TRAFFIC CONTROL PLAN -
ROAD CLOSED TO TRAFFIC
NOT TO SCALE

PROJECT NAME: GUILFORD
PROJECT NUMBER: BR0 1442(36)

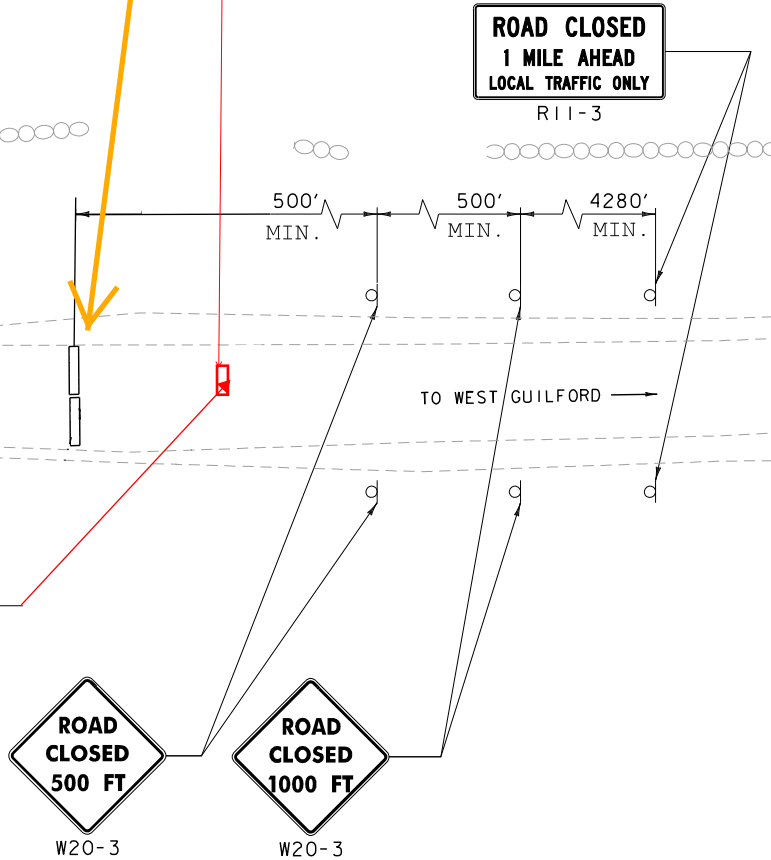
Is there a reason barrier is being chosen in place of Type III barricades? If barrier is essential, consider a row of Type III barricades (with the ROAD CLOSED sign mounted on one of them) in advance of the row of barriers. The barriers should have plenty of delineation on them to make them visible at night.

Don't need to spec FW, there is no such thing as fluorescent white. (Type IX white exists, but it's not fluorescent). B/W is fine to specify here.

WE ARE FIGURING THAT THE 6 DAY GLOW SIGNS WILL STOP THE TRAFFIC AND IF THEY DO NOT THE TYPE III BARRICADES WILL NOT. HAVEING THE CARS STOPED AT THE JERSEY BARRIERS RATHER THEN IN THE CONSTRUCTION SITE OR RIVER WOULD BE PREFERABLE.
